DESIGN 	DRAWN BY 	<b>DART AEROSPACE LTD</b> HAWKESBURY, ONTARIO, CANADA	
CHECKED 	APPROVED 	DRAWING NO. DSI 9252	REV. A SHEET 1 OF 2
DATE 03.02.21		TITLE KWIK FLOAT COMP. W/ DART SKIDS	SCALE NTS
A	03.02.21	NEW ISSUE

## **DART SERVICE INSTRUCTION**

TO AMEND BHA-DRA-358-11 SHEET 1, REV. D

AND IIN-D206-590 REV. NI

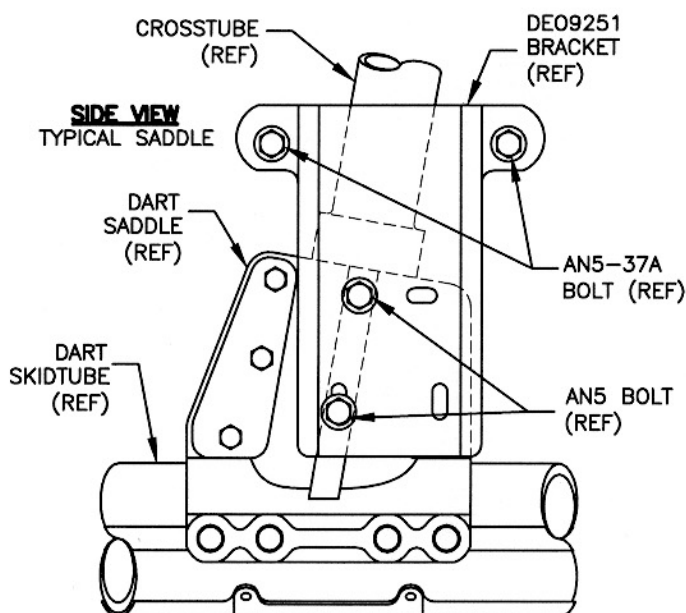
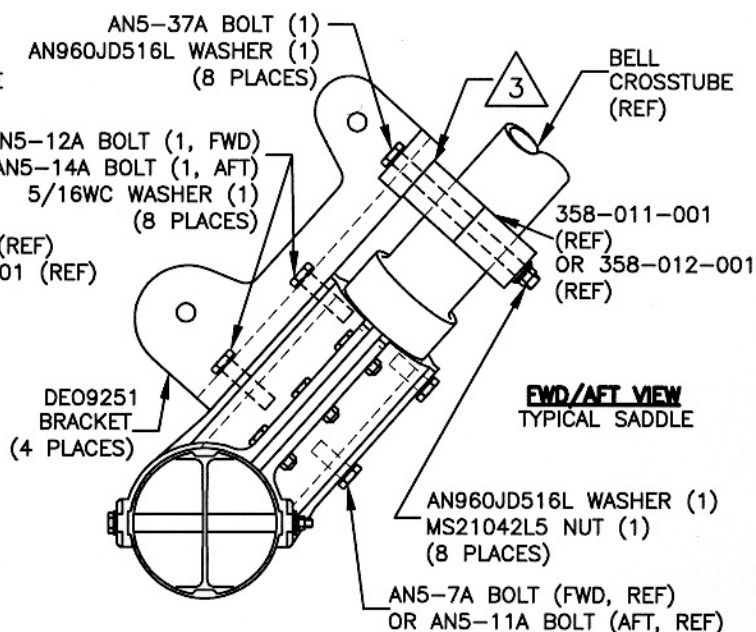
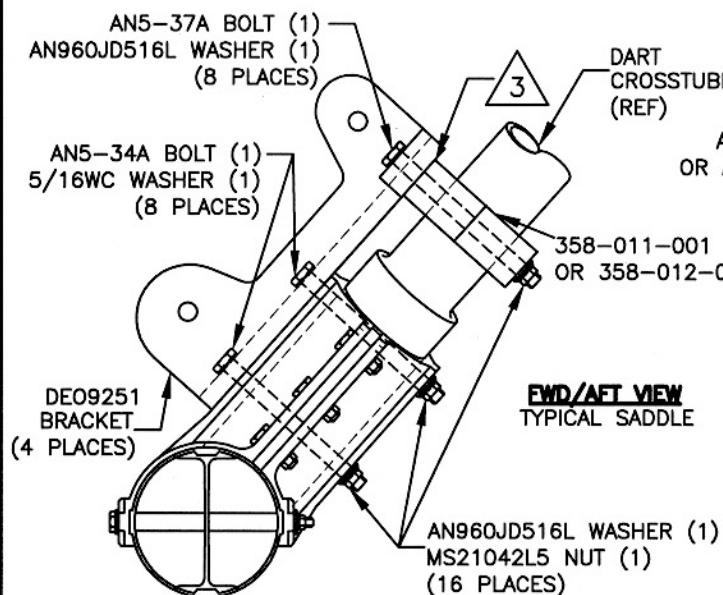
- 1) Replace 358-013-001 with DEO9251 Bracket.
- 2) Replace AN5-36A bolts with AN5-37A bolts and associated hardware per Figure 1/2/3.
- 3) 358-022-001 spacers are not required. It may be necessary to install extra AN960JD516L washers between DEO9251 and 358-011-001 / 358-012-001 to prevent DEO9251 Bracket from bending.
- 4) It is not necessary to lockwire bolt heads
- 5) Do not exceed torque of 140 in-lb on AN5 saddle bolts.
- 6) If installing on Dart D206-667-101/-201 crosstubes, replace AN5H13A with AN5-34A bolts and associated hardware per Figure 1.
- 7) If installing on Bell crosstubes, replace AN5H13A with AN5-12A (fwd xtube) and AN5-14A (aft xtube) and associated hardware per Figure 2.
